Reply to the reviewer 2's comment

Reviewer #2: In this study, the authors apply metrological techniques to the measurement of radiative efficiencies for select greenhouse gases, which can be used to reduce uncertainties in global warming potentials. The manuscript presents a very detailed uncertainty analysis, going far beyond anything I have previously seen in the determination of radiative efficiencies. It also contains the first radiative efficiency value for PFME, a future refrigerant alternative. I recommend this for publication once the following issues are addressed.

Figure 1. Illustration of the propagation of a light beam inside the reference cell. The effective optical path length is slightly longer than the length determined from a simple mechanical measurement.

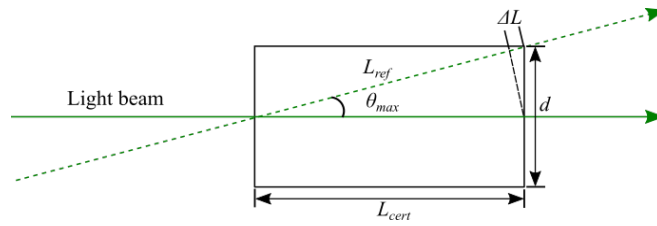
(3) The path length of the reference cell was determined (mechanically) to be 20.01 ± 0.05 mm. During a measurement using the 125HR spectrometer, however, the IR beam is not collimated through the cell but is focused at the center. This means that the effective optical path length is slightly longer than that determined from a simple mechanical measurement ($< \sim 0.5\%$ longer). Did the authors consider this at all? Simple ray-tracing software could determine this optical path length more accurately.

- Yes, we had considered this, although we did not thoroughly discuss or include it in the uncertainty analysis. This was because we used a rather short reference cell (2 cm) and a smaller aperture size (2 mm). The shorter length and smaller aperture size benefited from a lower potential for error due to the possible path length deviation from the angle of the actual light beam from the optical axis θ .

Discussion regarding this issue with respect to TDLAS experiments has been published in a study by Nwaboh et al. (2014). A conservative approach is to consider that the angle of the actual light beam deviates at the maximum angle from the optical axis $\theta = \theta_{max}$. Figure 1 (below) illustrates the situation when the conservative approach is used. The effective optical path length L_{ref} is a function of the measured length from mechanical measurement L_{cert} , free optical aperture d , and θ_{max} . The relationship between the parameters are $\Delta L = L_{cert} \times (1/\cos \theta - 1)$ with $|\theta| \leq |\theta_{max}|$, and $\tan \theta_{max} = d/L_{cert}$.
